Central Valley Regional Water Quality Control Board

ORDER AMENDING CLEAN WATER ACT SECTION 401 WATER QUALITY CERTIFICATION AND ORDER FOR UNION PACIFIC RAILROAD (UPRR), UPRR VALLEY SUBDIVISION MILE POST 310.34 BRIDGE REPLACEMENT PROJECT (WDID NO. 5A45CR00595A1), SHASTA COUNTY

AMENDMENT:

Figure 2. Project Impacts Map

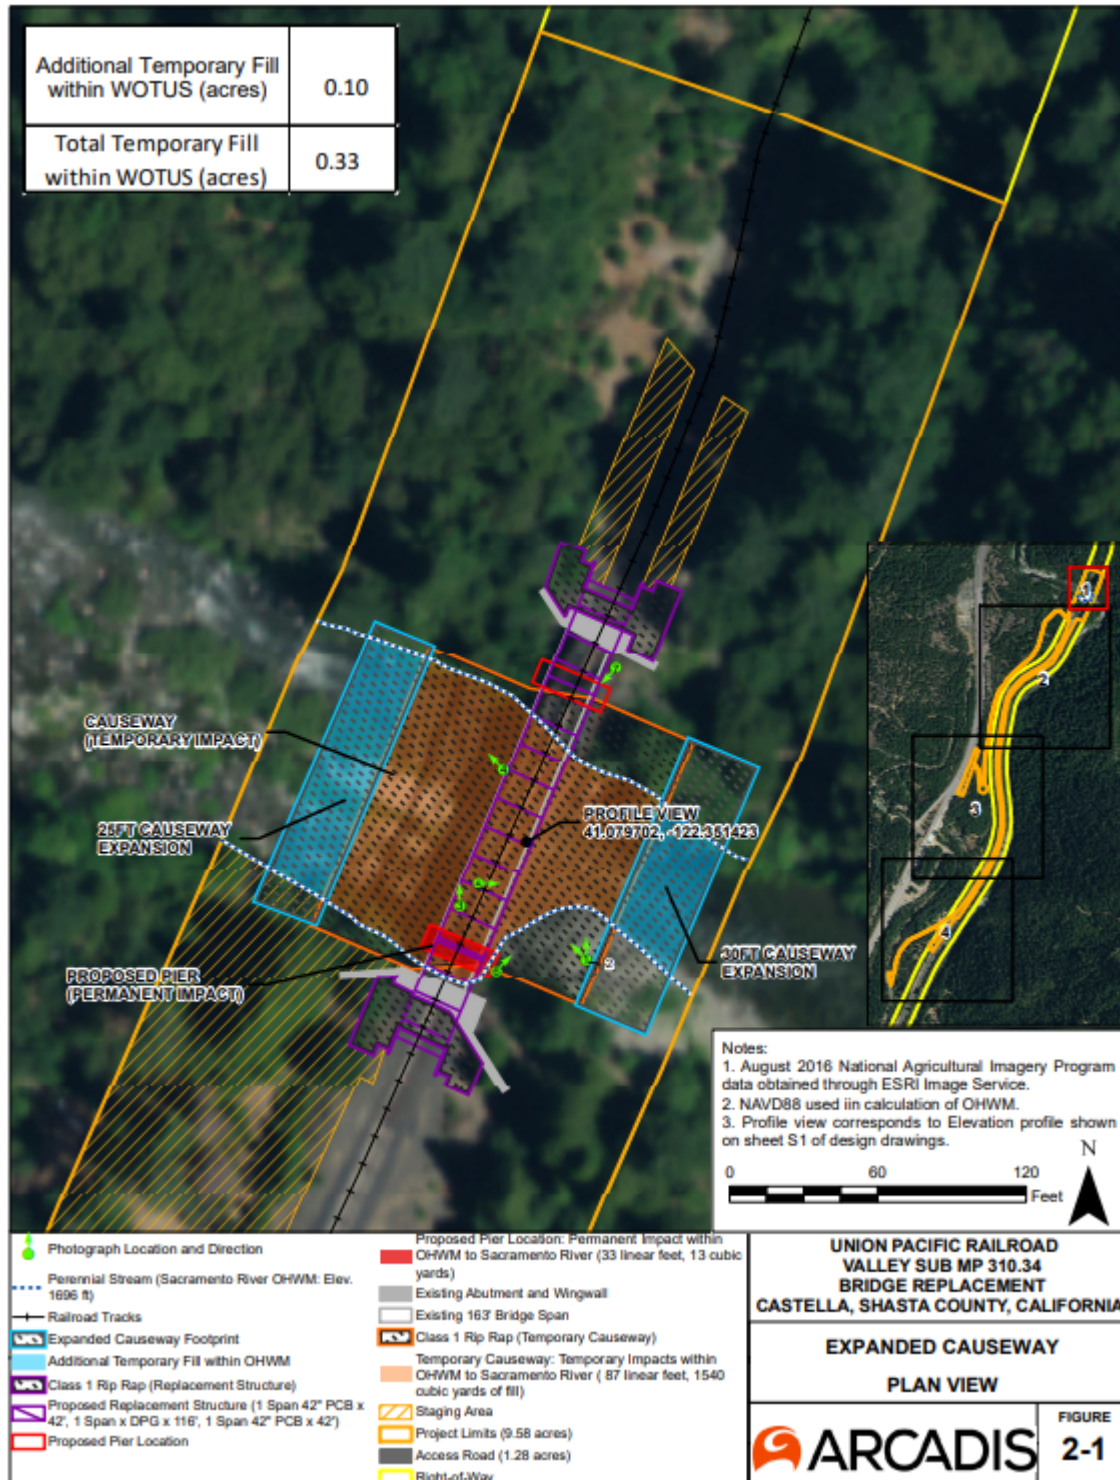
Union Pacific Railroad Company is requesting an amendment to the Section 401 Water Quality Certification and Order to expand the temporary causeway within the Sacramento River to better facilitate the movement of construction equipment. This will result in lengthening the temporary causeway on the downstream side by an additional 30 feet and the upstream side by an additional 25 feet. The expansion will increase the temporary impacts from 0.23 acre to 0.33 acre.

Therefore, Section IV, Project Description; VII, Description of Direct Impacts to Waters of the State and Table 1; XIII, Fees Received; Attachment A, Figure 2; and Attachment B, Table 2 are amended in underline format below.
